CITY OF ALBUQUERQUE

RE: Lot 5 Block 8 Unit 22 SAD 228
Volcano Cliffs Subdivision
6412 Canavio St NW
Request for Permanent C.O. – Not Accepted
Engineers Stamp Date 5/24/17 (D10D003E5)
Certification Dated: 1/10/18

RE: Volcano Cliffs Subdivision Lot 5, Block 8, Unit 22 **6412** Canavio Pl NW Grading and Drainage Plan Engineers Stamp Date 5/24/17 (D10D003E5)

GRADING & DRAINAGE PLAN 6412 Canavio Place NW LOT, 5. BLOCK 8, UNIT 22 VCS

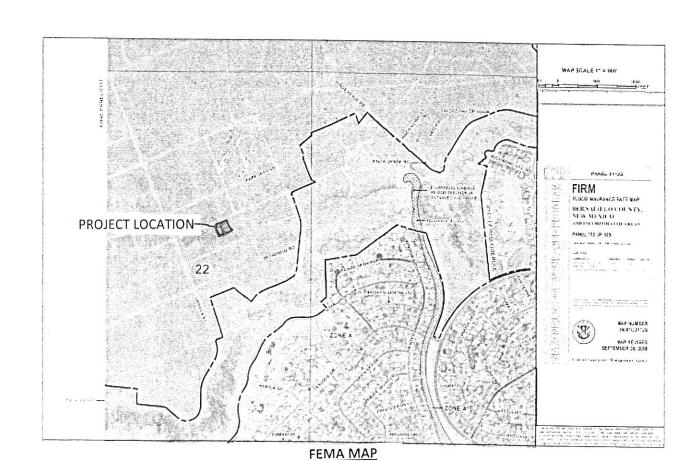
• An opening in the block fence, on the west side of the property, must be provided, according to the approved plan dated 5/24/17.

- All dirt piles, debris and concrete must be removed in and around the entire site.
- The dumpster located on the west side of the property must be removed.
